Notice of Allowability

10/604,734

MATTSSON ET AL.

EXAMINER'S AMENDMENT

Fig. 1

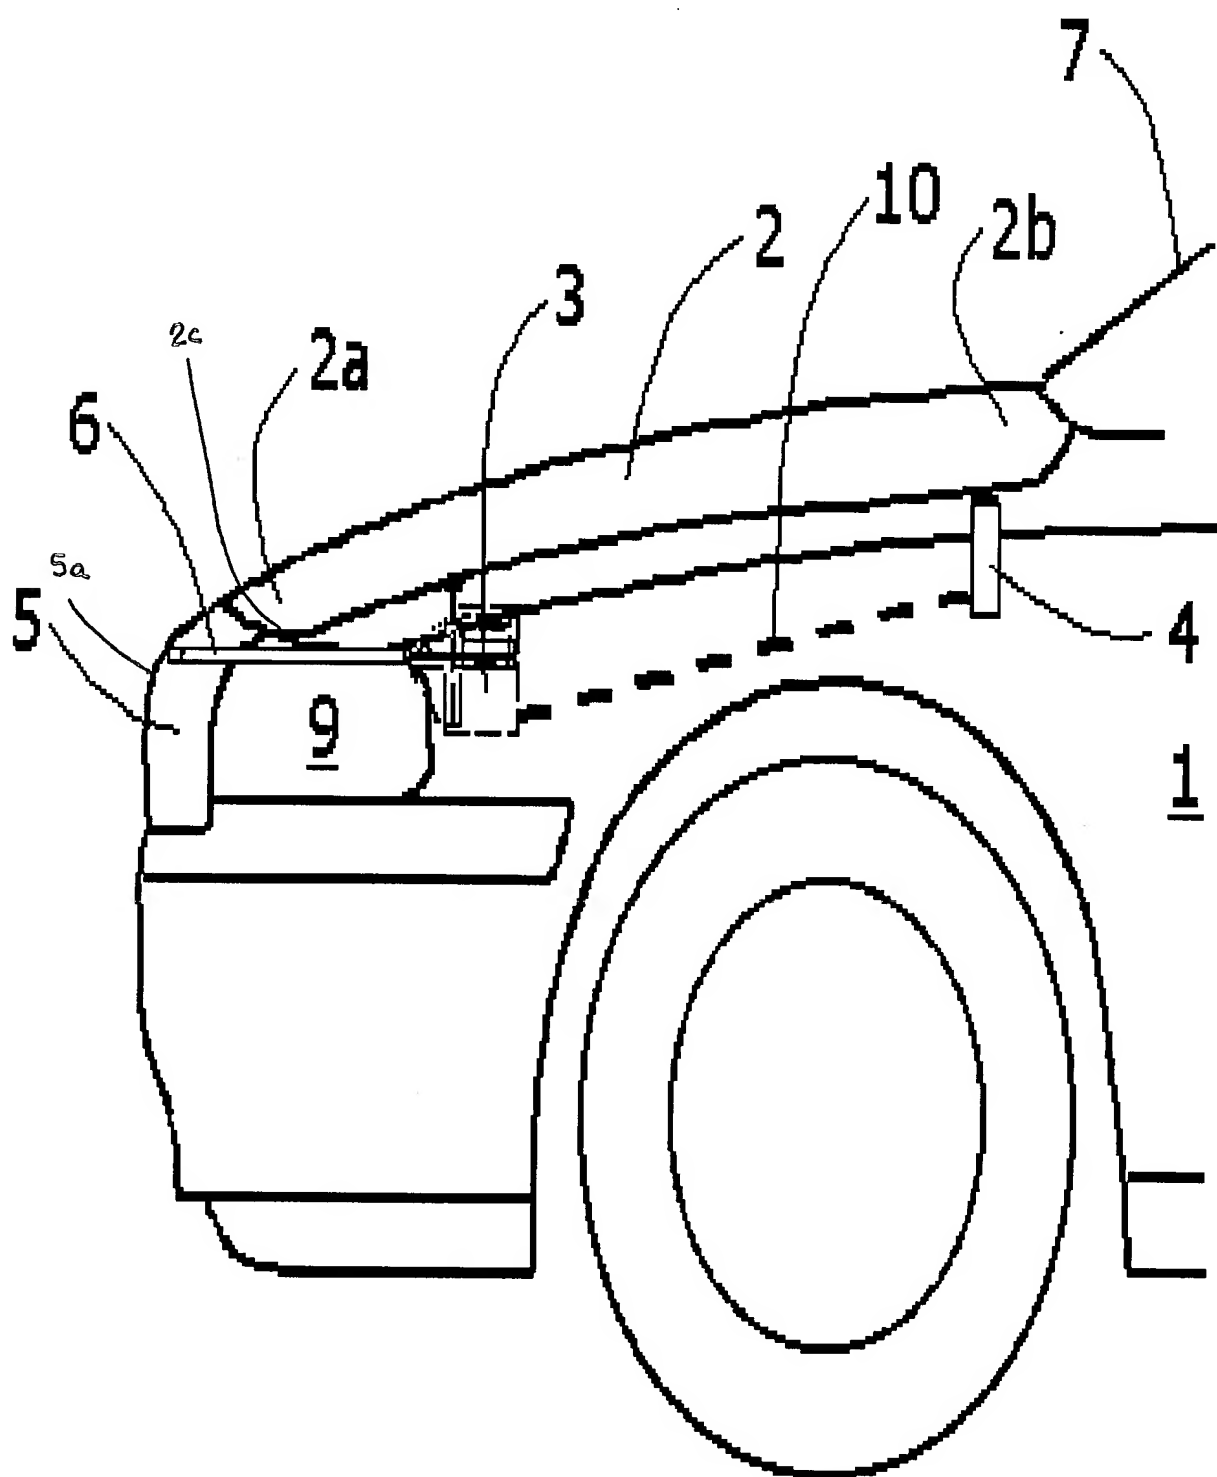
The latch mechanism **2c** and the grille opening reinforcement assembly **5a** have been added to **Figure 1**.

In order to avoid abandonment of the application, applicant must make these above agreed upon drawing changes.
